### **Supplemental Instructions**

*Rifle Fire Protection District  
Fire Station #3  
416 Last Chance Drive  
Rifle, CO 81650*

**Architect's Supplemental  
Instruction NO: 5**

*South Elevation*

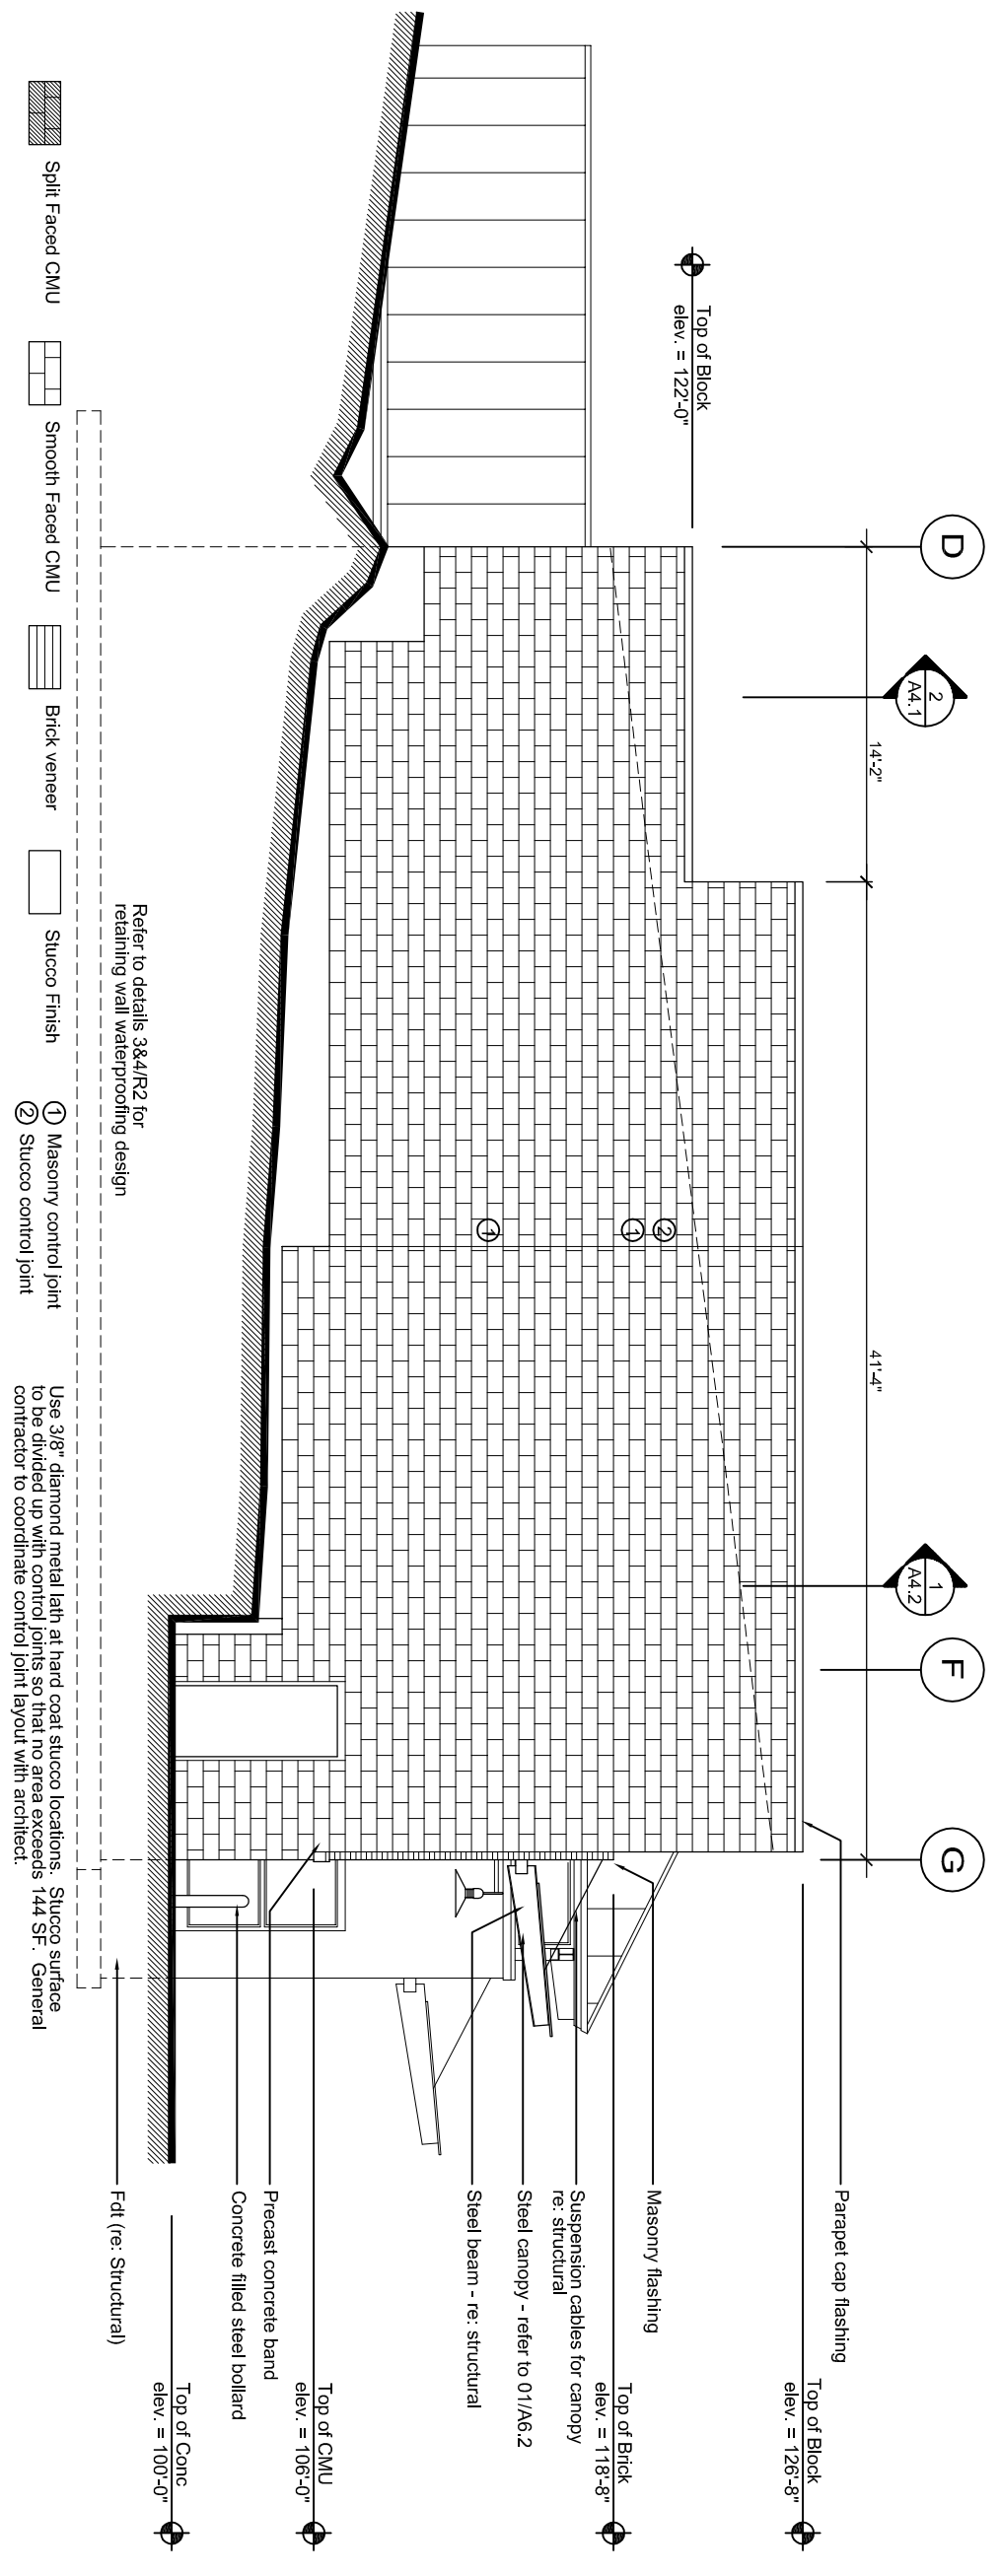
*Refer to the attached sheet for the revised south elevation. There is no graphical change to the elevation – the text 'stucco finish' (which was pointing to the masonry wall) has been removed from the attached drawing.*
